## **NOTICE TO ALL FIRMS**

Re: Addendum Number 3  
IFB # C1576 – D442 Classroom Renovation

PROJECT:  
D442 CLASSROOM RENOVATION  
POMERANTZ 300 7TH AVE  
NEW YORK NY 10001

SEAL & SIGNATURE:	DATE: 6.7.2023
	PROJECT No: 22520.3
	DRAWING BY: MS/MH
	CHK BY: DH & CK
	DWG No:
	<b>A-300.00</b>
SCALE: AS NOTED	6 of 12

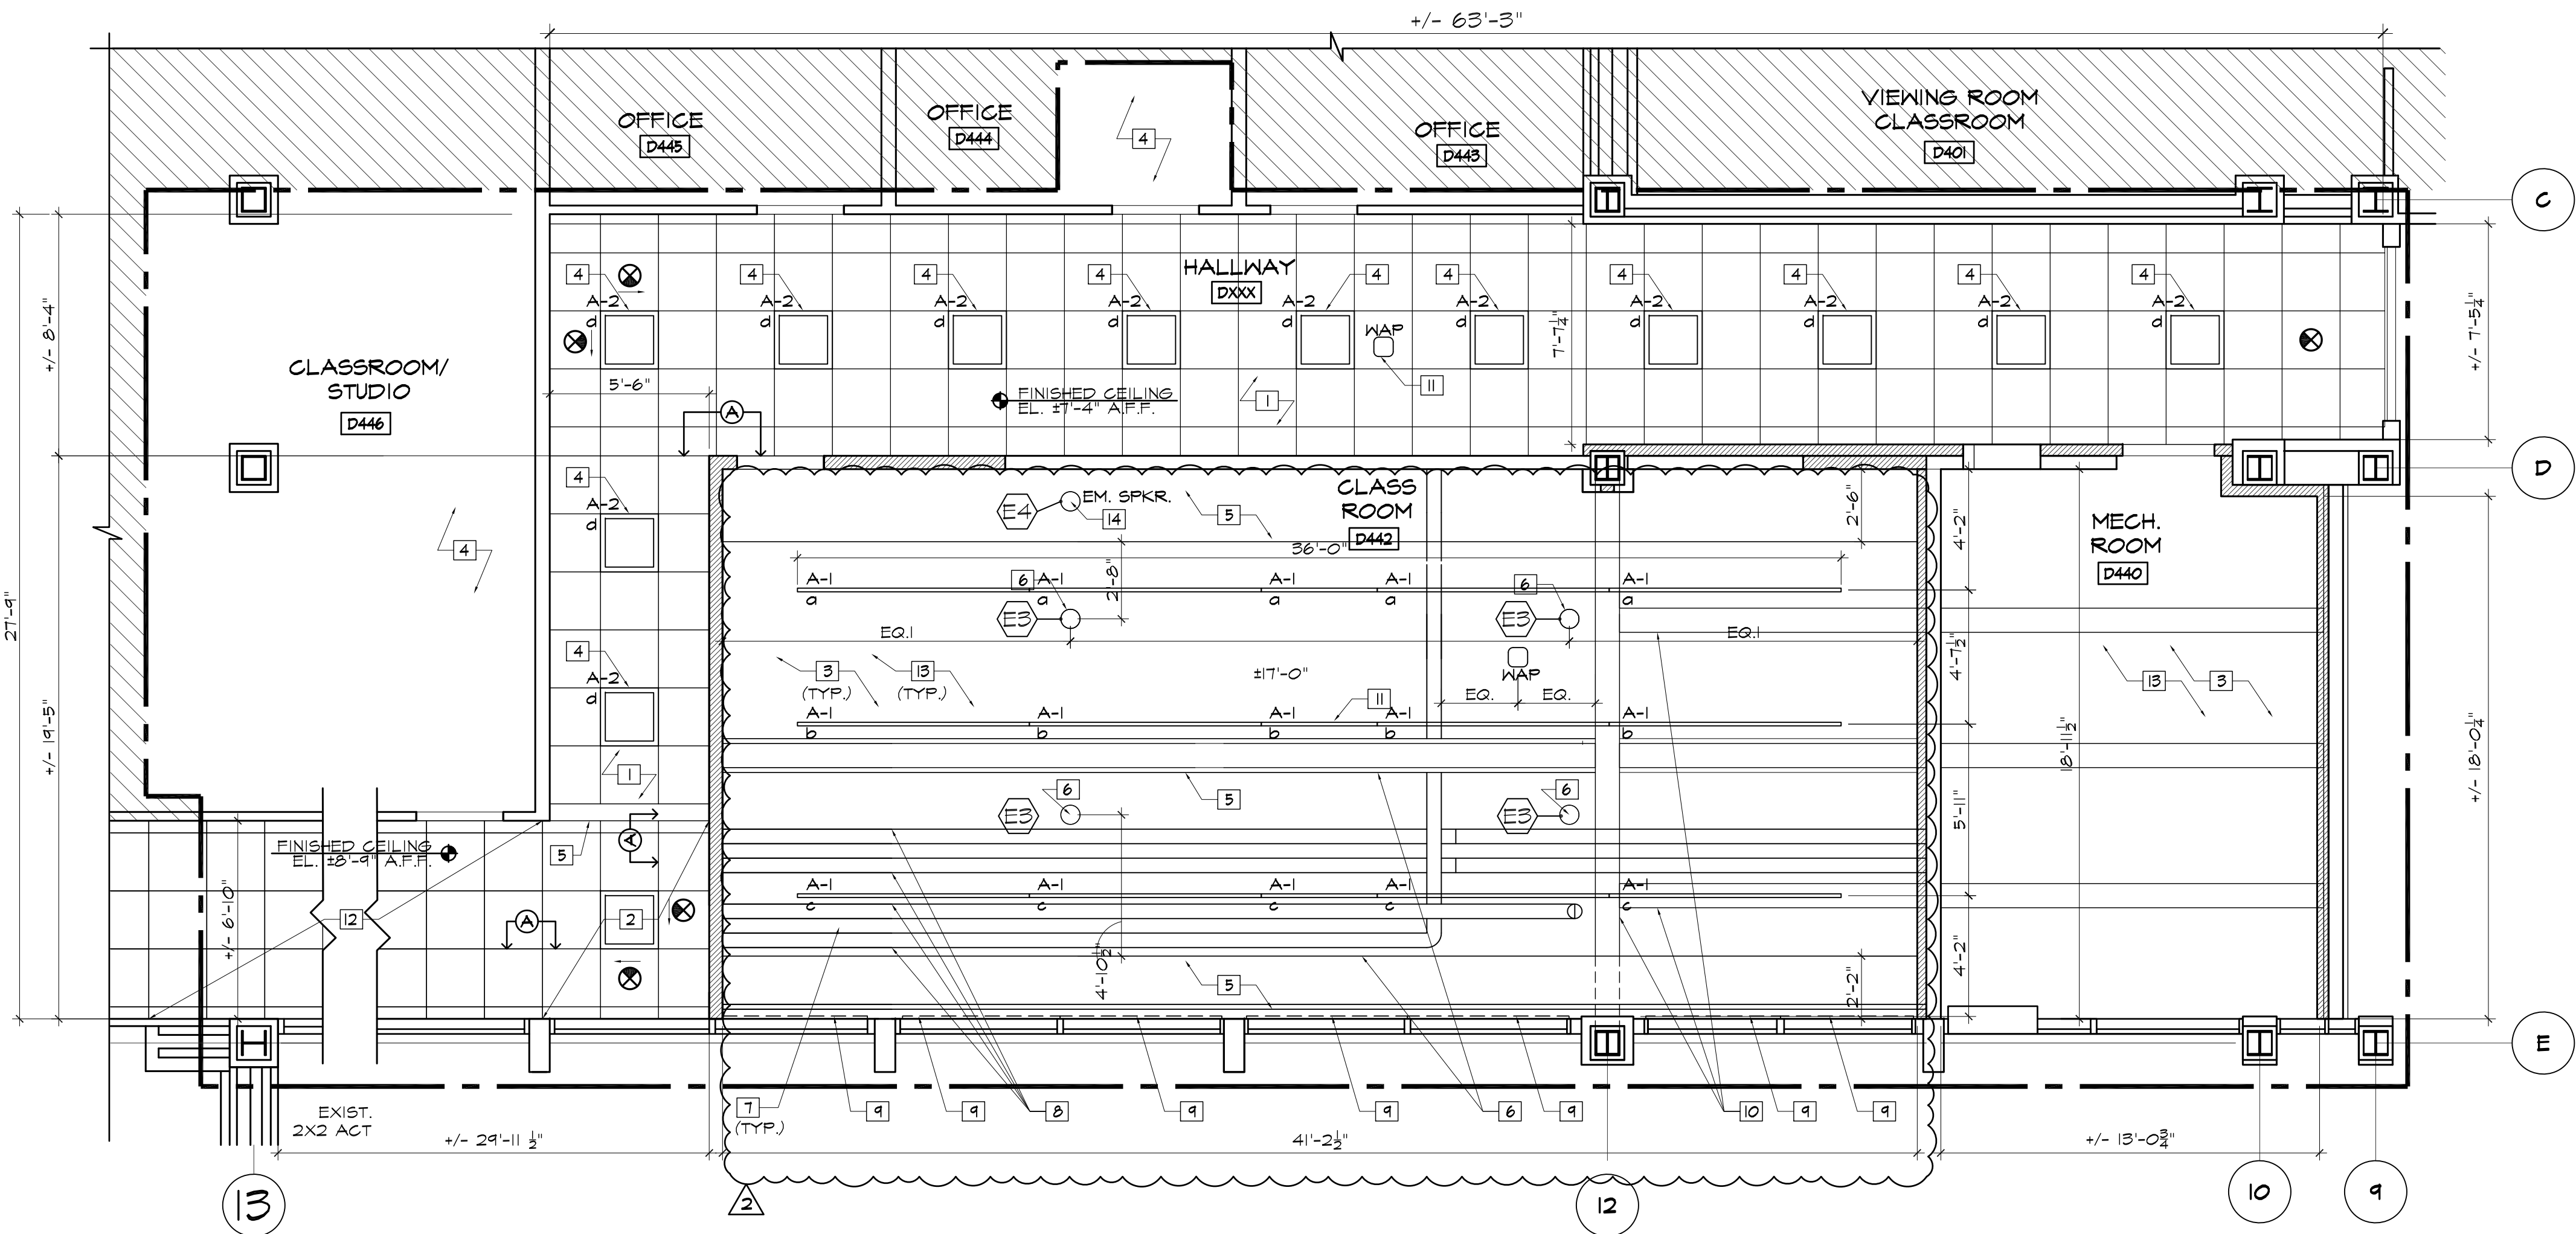
- 1) The due date for the subject bid has been changed from 7/7/2023, 12:00PM to 7/11/2023, 12:00 PM. The RFQ must be emailed to [purchasingbids@fitnyc.edu](mailto:purchasingbids@fitnyc.edu) on or before 7/11/2023, 12:00 PM.
- 2) Please find the two revised drawings A-300 and A-400 (attached below), indicating the changes to the RCP and the elevation.
